| Well Name: POKER LAKE UNIT 13-1 PC | Well Location: T24S / R29E / SEC 13 / SWNE / 32.218157 / -103.934854 | County or Parish/State: EDDY / NM |
| Well Number: 805H | Type of Well: OIL WELL | Allottee or Tribe Name: |

Sundry ID: 2855417

Type of Action: APD Change

| C-102 Submit electronically Via OCD Permitting | State of New Mexico Energy, Minerals & Natural Resources Department OIL CONVERSION DIVISION | Revised July, 09 2024 |

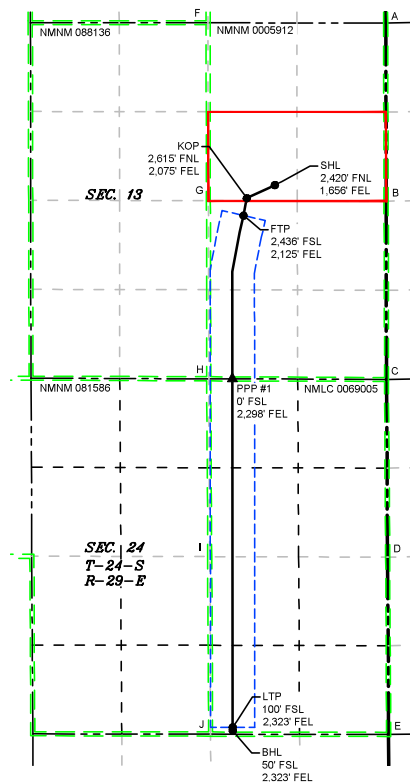
XTO Permian Operating, LLC. respectfully requests approval to make the following changes to the approved APD. Changes to include KOP, FTP, proposed total depth, and pool.

KOP: 2420 FNL & 1656 FEL OF SECTION 13-T24S-R29E 2615 FNL & 2075 FEL OF SECTION 13-T24S-R29E
FTP: 2059' FNL & 2318' FEL OF SECTION 13-T24S-R29E 2436' FSL & 2125' FEL OF SECTION 13-T24S-R29E

The proposed total depth is changing FROM 18817 MD; 9714 TVD TO 17382 MD; 9705 TVD.
